东莞市汇泉塑胶五金有限公司
 DONGGUAN HUIQUAN PLASTIC HARDWARE CO., LTD
 汇泉塑胶

TITLE:	EI38 (5+5)	SCALE:	
DRAWING NO:	EB-EI-3802	UNIT:	m/m
MATERIAL:	FR530	UL REC:	94V-0
PIN MATERIAL:	磷青铜	TOLERANCE	
 PIN PITCH ±0.20 DATE: 2022.03.03 ANGLE ±1°		0<L≤4: ±0.1	
		4<L≤16: ±0.2	
		16<L≤63: ±0.3

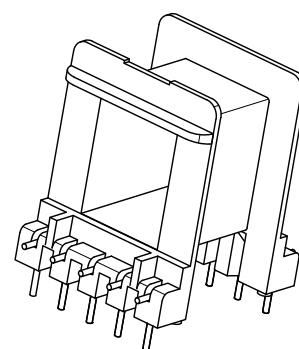
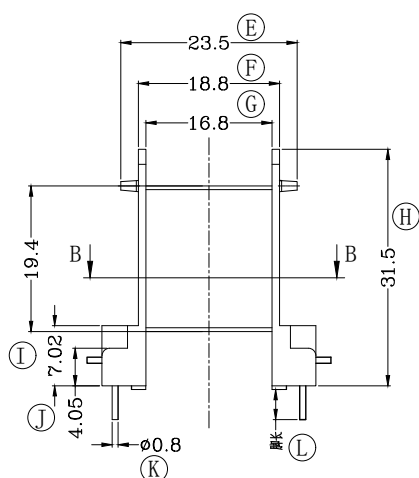
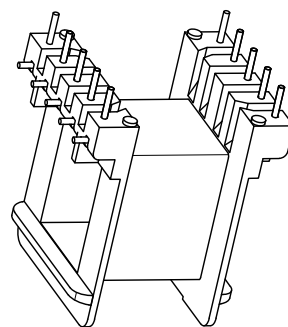
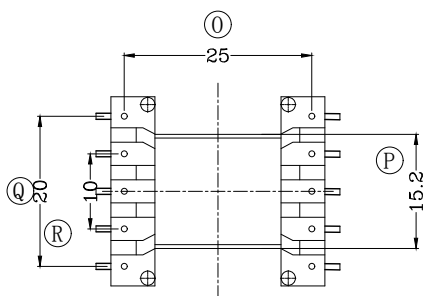
日期	更改记录	明细
2022-7-11		D顶部增加0.8MM到32.5MM
2022-9-15		顶部倒角由R2.0变更为R1.0. pin台减胶0.5MM, I由7.52变更为7.02, J由4.55变更为4.05MM, D由32.5MM变更为32MM, H由31.2MM变更为31.5MM.
